Tehnika: Pomivalni stroji	Izmenjevalni ventil PMS_2019_01	Izdelal: Tehnična podpora
Datum: 2019-10-10		Verzija : 00

Product: Dishwasher	Diverter valve PMS_2019_01	Reference: Service Support
Update: 2019-10-10		Version: 00

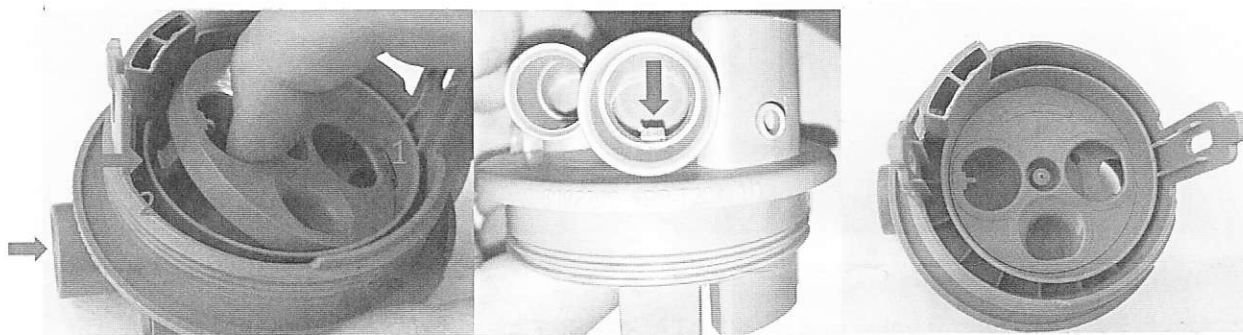
Od datuma 17.09.2109 oz. serijske številke 9383... je nov izmenjevalni ventil. Izmenjevalni ventil ni kompatibilen na starih aparatih (do serijske 9383...) zaradi tega je potrebno ob menjavi izmenjevalnega ventila vstaviti tudi nastavek.

1. Odklopite kabel izmenjevalnega ventila in odstranite stari izmenjevalni ventil iz dveh zaskočk (en spredaj en zadaj).

2. Vstavite nastavek. Nastavek je možno vstaviti samo v eni poziciji. Najprej vstavite vložek kot prikazuje spodnja slika nastavek (morate slišati klik).

3. Pritrdite nov izmenjevalni ventil in **NAREDITE TOTAL RESET 02.**

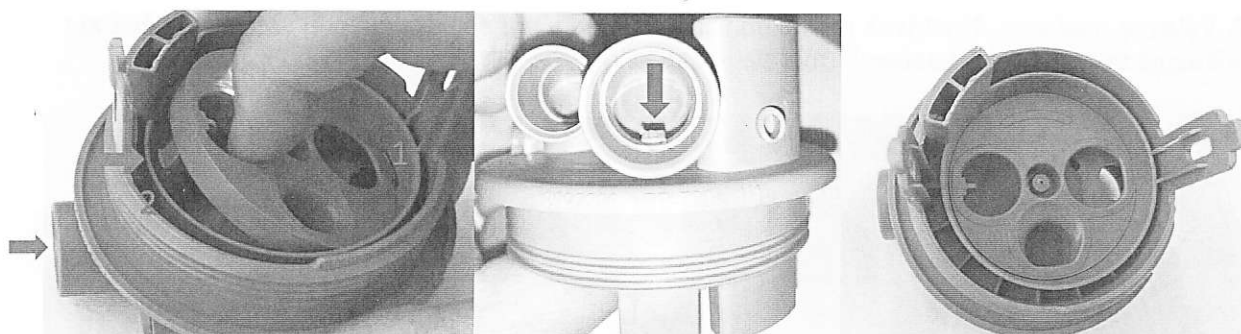
From date 17.09.2109 or. Serial number 9383... there is a new diverter valve. New diverter valve isn't backward compatible (until serial 9383...) because of that it is necessary to install also the insert.

1. Disconnect wiring harness and remove the diverter valve from two hooks (one front one back).

2. Install the insert. Insert is possible to install only in one position. Install it in sequence like on photo bellow (a click must be heard).

3. Attach the new diverter valve and do a **TOTAL RESET 02**.
